1 Addendum 1		03/28/2017
Revisions:		Date

Drawing Title	
SECOND FLOOR PLAN	
Approved: Project Director Approver

Project Title	
VA HEALTH CARE SYSTEM	
Location VAS 438-16-104 BLDG. 5 CHAPEL SIOUX FALLS, SD 57105	
Date	2017.03.13
Checked	RLK
Drawn	Author

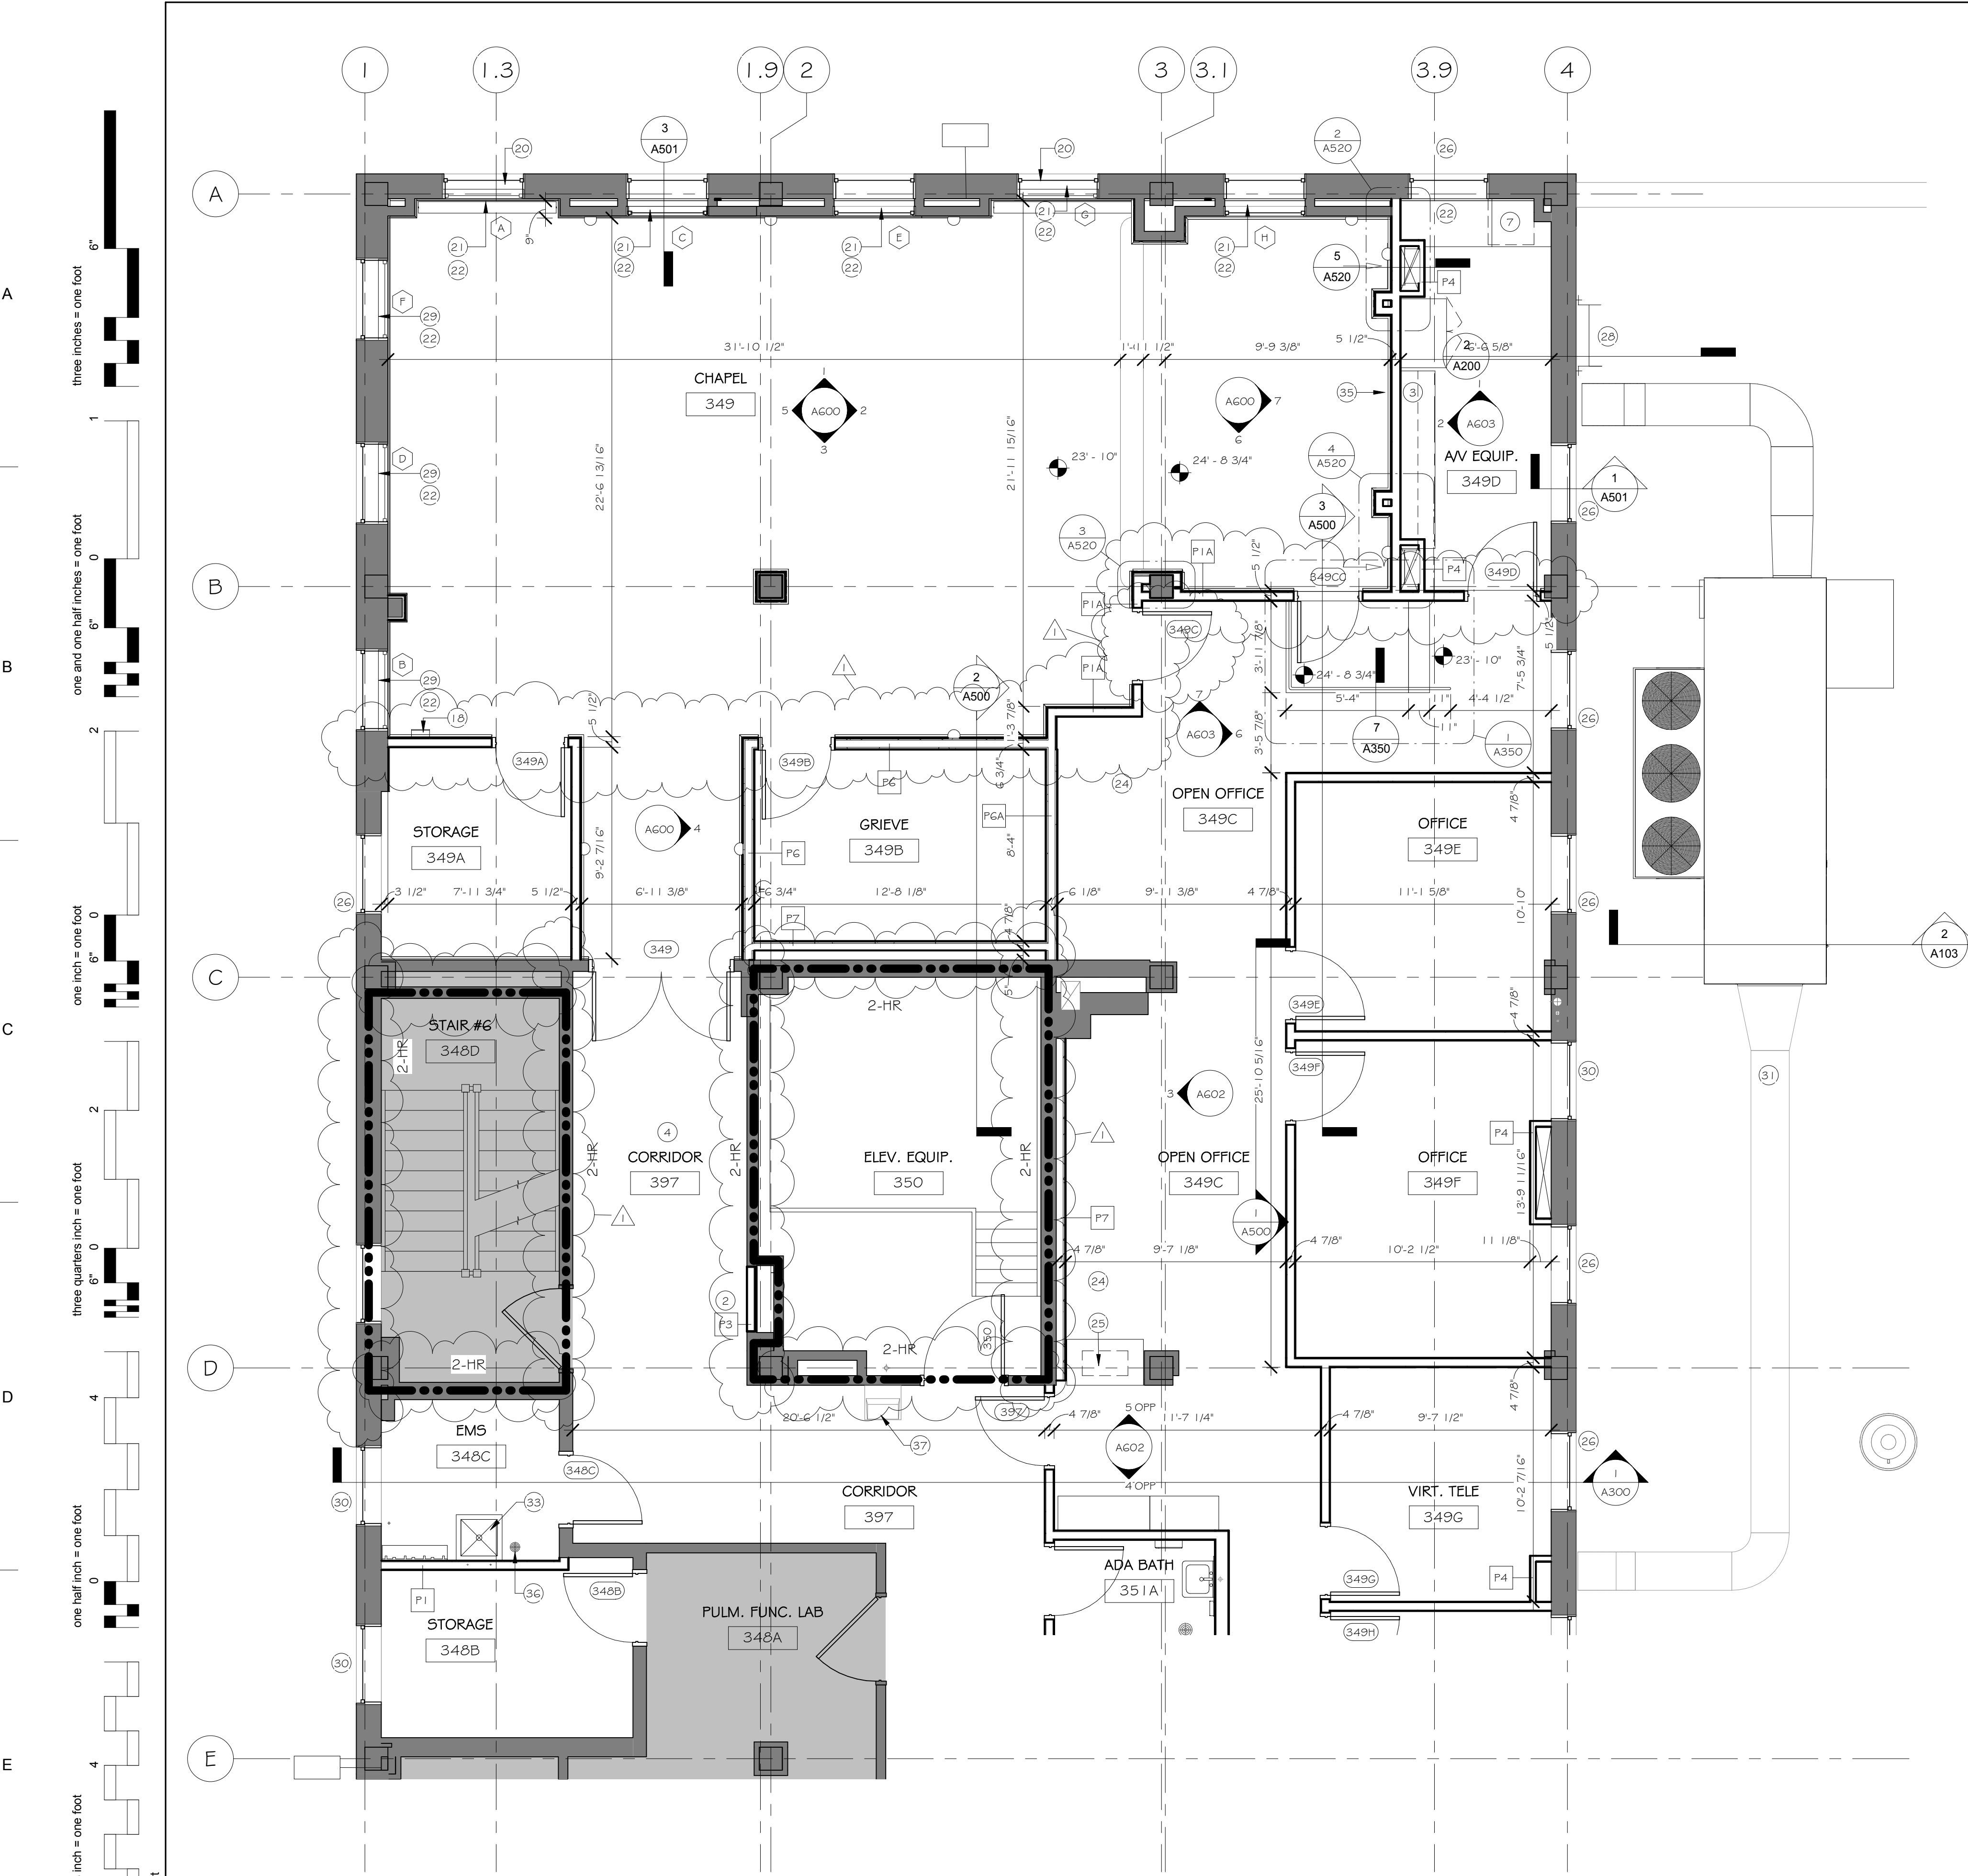
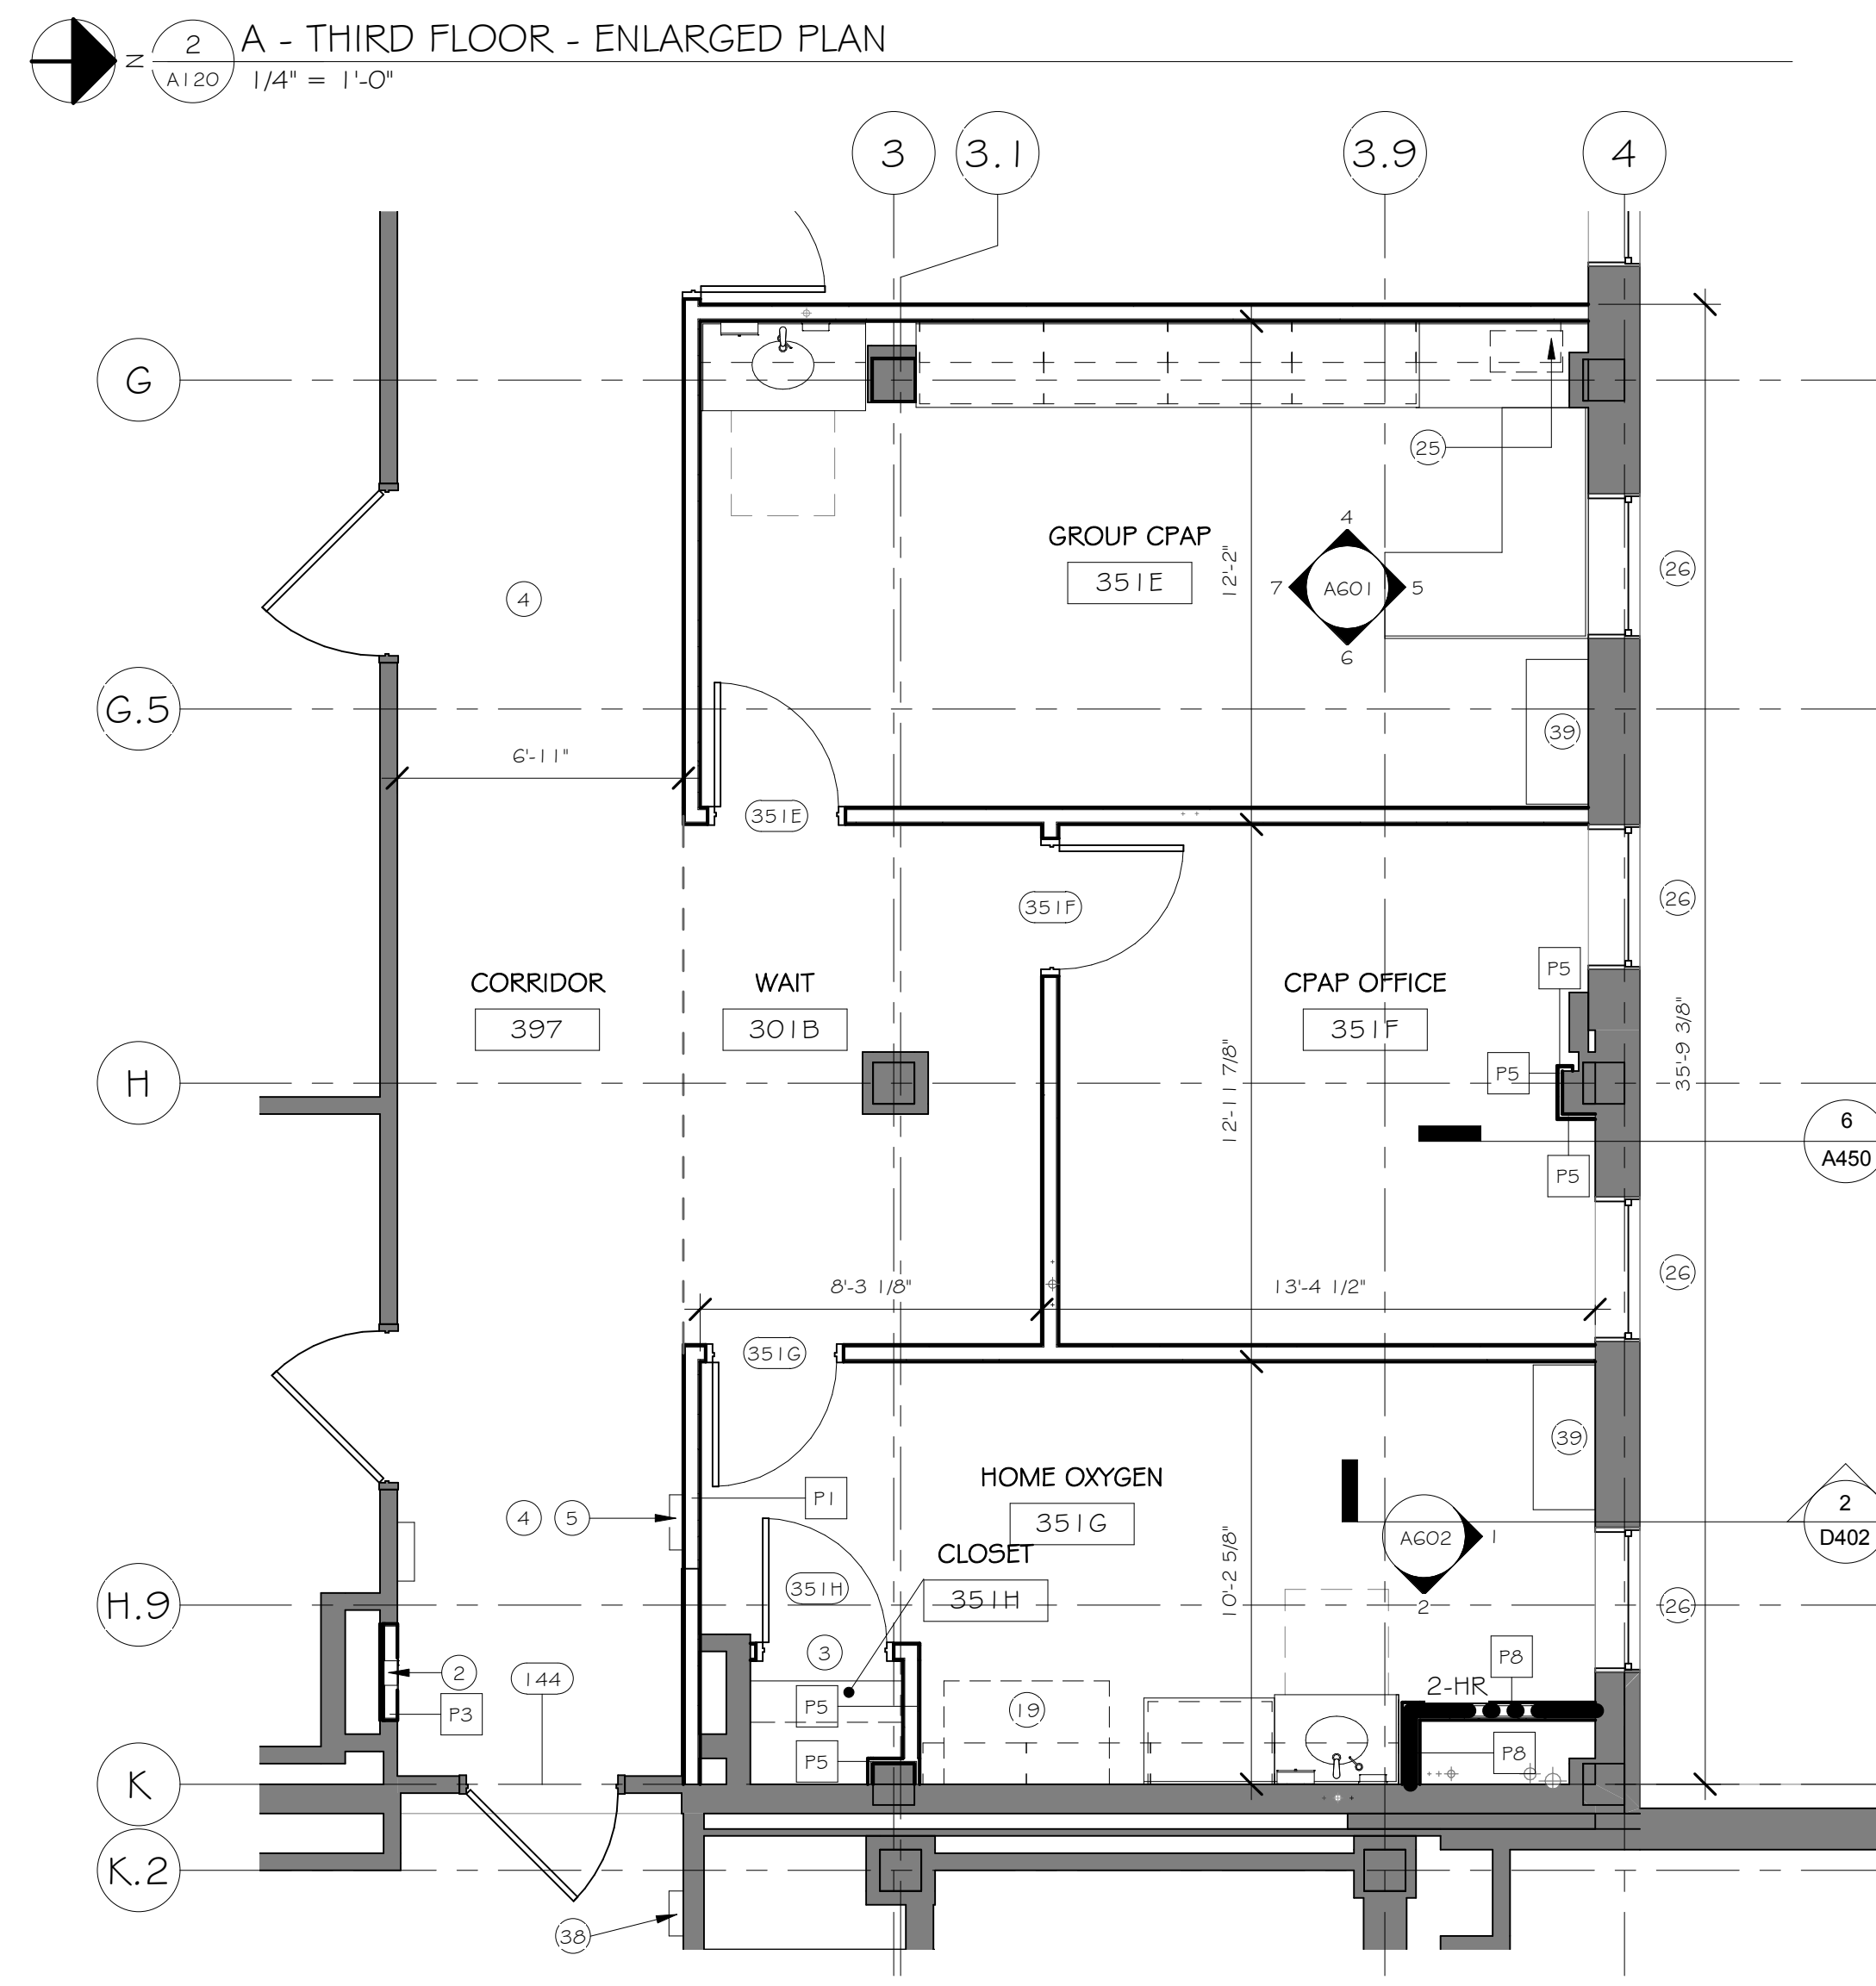
1 NEW 2 HR FIRE WALL SHAFT ASSEMBLY FROM FLOOR TO UNDERSIDE OF DECK, TO BE PAINTED TO MATCH ADJACENT WALL. CONTRACTOR TO FIRE CAULK ALL PENETRATIONS GOING THROUGH 3RD FLOOR SLAB AND CAULK ALL PENETRATIONS COMING THROUGH SHAFT WALL.

2 NEW DUCT PENETRATION THROUGH WALL. G.C. TO CAULK & PAINT WALL TO MATCH ADJACENT WALL ASSEMBLY (RE: MEP FOR SIZE OF OPENING).

3 CONTRACTOR TO REBUILD TOP OF SHAFT TIGHT TO ALL PENETRATING UTILITIES. CONTRACTOR TO FIRE CAULK ALL PENETRATIONS GOING THROUGH 3RD FLOOR SLAB AND CAULK ALL PENETRATIONS COMING THROUGH SHAFT WALL.

4 RELOCATE EMS/JOHNSON CONTROL PANEL FROM 3RD FLOOR TO 2ND FLOOR.

NOTE TO CONTRACTOR:

CONTRACTOR TO KEEP FIRE RATINGS IN TACT AT ALL TIMES DURING CONSTRUCTION BY PROVIDING ONE OF THE FOLLOWING SAFETY OPTIONS:

ONE - LEAVE THE EXISTING SPRINKLER SYSTEM OPERATIONAL IN THE RENOVATED AREA AND PROVIDE UPRIGHT SPRINKLER HEADS ON THE EXISTING PIPE TO PROVIDE COVERAGE IN THE AREA OF WORK PER NFPA 13 DURING CONSTRUCTION. THIS WILL LIKELY INVOLVE MOVING SPRINKLERS TO WITHIN 12 INCHES OF THE DECK ABOVE. AFTER THE NEW SPRINKLER PIPING IS INSTALLED TESTED AND APPROVED, THE SPRINKLERS AT THE DECK LEVEL AND THE EXISTING PIPING SHALL BE REMOVED.

TWO - CONTRACTOR MAY SHUTDOWN THE EXISTING SPRINKLER SYSTEM IN THE AREA OF WORK PROVIDED THAT THE CONTRACTOR INSTALL A 1-HOUR FIRE-RESISTANCE RATED SEPARATION BETWEEN EVERY OCCUPIED SPACE ADJACENT TO THE CONSTRUCTION AREA. CONTRACTOR SHALL COORDINATE WITH THE VETERANS ADMINISTRATION, THE CONTRACTING OFFICER, AND THE AEC ALL FIRE-RESISTANCE RATED SEPARATIONS SHALL COMPLY WITH NFPA 101 AND UL LISTINGS.

THE SPRINKLER MAIN LOCATED IN THE CORRIDOR IS REQUIRED TO REMAIN ACTIVE DURING BUSINESS HOURS FOR THE DURATION OF THE CONSTRUCTION PERIOD IN ORDER TO SUPPLY THE SPRINKLERS IN THE RESPIRATORY CARE PORTION OF THE FLOOR (NOTED AS OUT OF CONTRACT ON THE PLAN). THE CONTRACTOR IS PERMITTED TO TAKE THE SPRINKLER MAIN TEMPORARILY OUT OF SERVICE AFTER HOURS TO ALLOW THE REMOVAL OF THE DEMOLISHED SPRINKLER BRANCH PIPING AND FOR RE-CONNECTION OF THE NEW SPRINKLER BRANCH PIPING. CONTRACTOR SHALL PROVIDE A FIRE WATCH DURING THE TIME THE SPRINKLER SYSTEM IS TAKEN OUT OF SERVICE. THE TIMING AND DURATION OF THE SPRINKLER SYSTEM SHUTDOWN SHALL BE COORDINATED WITH AND APPROVED BY THE VA AND AUTHORITY HAVING JURISDICTION.
